Service Bulletin

Bulletin No.: 23-NA-122

Subject: Engine Oil Leak

Brand:	Model:	Model Year:		VIN:		Engine:	Transmission:
		from	to	from	to		
Buick	Encore GX	2020	2024	—	—	1.2L Turbo (RPO LIH)	—
	Envista	2024					
Chevrolet	Trax	2024					
	Trailblazer (VIN M)	2021

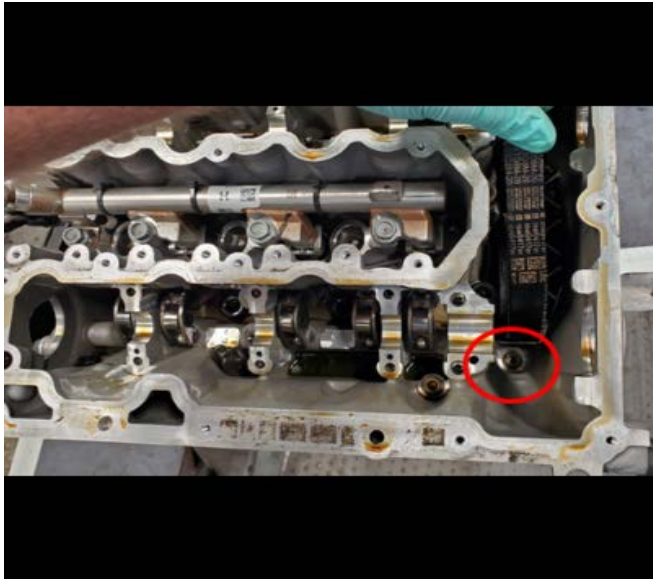
<p>Involved Region or Country</p>	<p>North America</p>
<p>Condition</p>	<p>Some customers may comment on oil leak between the engine front cover and turbocharger heat shield.</p>
<p>Cause</p>	<div data-bbox="683 258 1333 835" data-label="Image"> </div> <p data-bbox="1419 842 1481 863">6373157</p> <p data-bbox="540 869 1318 932">This condition may be caused by porosity from the engine block bolt holes. Important: Do Not replace the engine for this condition.</p> <div data-bbox="683 942 1333 1520" data-label="Image"> </div> <p data-bbox="1419 1526 1481 1547">6373160</p> <p data-bbox="540 1568 1446 1623">– Oil leaking was found to be coming from porosity between the cylinder head bolt hole and the engine mount boss, bolt hole.</p>
<p>Correction</p>	<p>Remove the cylinder head bolt to apply Loctite® 565 to a new bolt. Refer to the Service Procedure.</p>

6373158

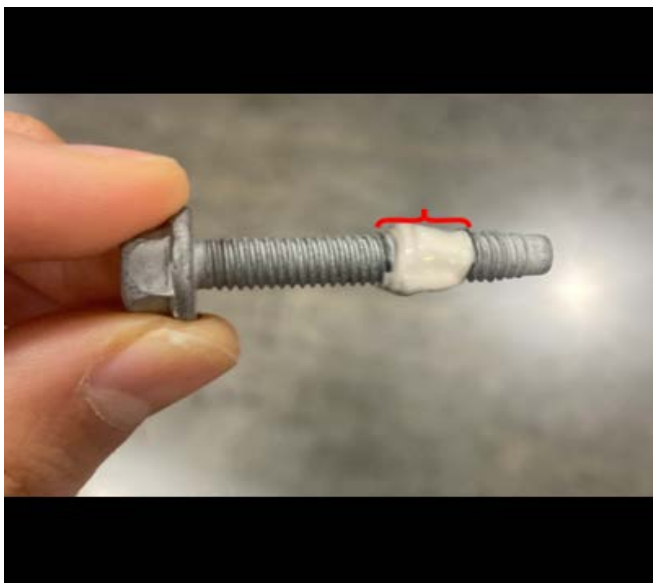
Note: Camshaft removed for clarity.

1. Remove the exhaust camshaft sprocket and position aside. Refer to *Camshaft Exhaust Sprocket Replacement* in the Service Manual.
2. Remove the cylinder head bolt.
